Specific Conditions for manual Frequency Restoration Reserve (mFRR) Service

Centrica Business Solutions (REstore) comments to Elia following formal consultation

November 4th, 2019

Figure: illustration of how the parent-child linking of bids could work to allow BSPs to better split aggregated pools with different prices

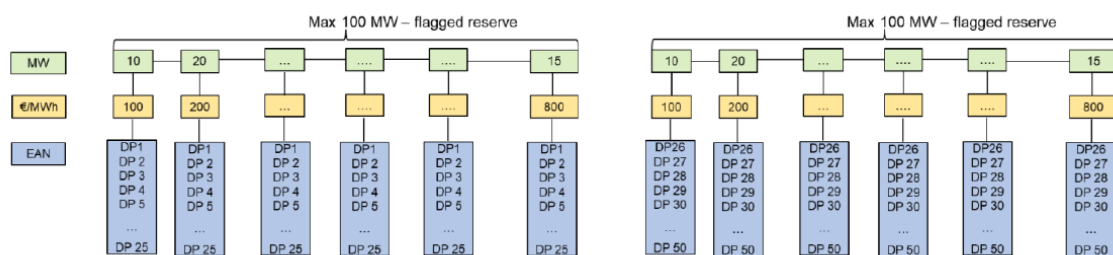
As pointed out in the previous consultation on the design note for the mFRR 2020, CBS asks Elia to consider implementing the possibility to offer sub-bids, below the maximum “overarching” 100 MW bid, based on the illustrating figure below. Such a scheme would allow BSPs to offer to Elia, from a larger 100 MW bid with a unique activation price, a combination of smaller bids (that would be linked to each other), with different activation prices. Concretely, this would add liquidity on the mFRR merit order, avoiding having too large 100MW blocks with a unique price.

In order to be workable for BSPs, such a model would however need to allow BSPs to include same Delivery Points in several of the sub-bids (as long as a given DP is not included in 2 overall bids). In the example below, the DPs 1 to 25 would all be part of the max 100 MW overarching bid 1, and included also in each sub-bid linked to this one. This feature is needed to preserve the added value of aggregation, allowing a BSP to provide the mFRR volume required by Elia during an activation or an availability test using whatever DPs available in the overarching bid (as it is the case today when using only overarching maximum 100Mw bids).

CBS believes such a model would bring value both to the BSPs and to Elia, without introducing additional complexity compared to the existing model.
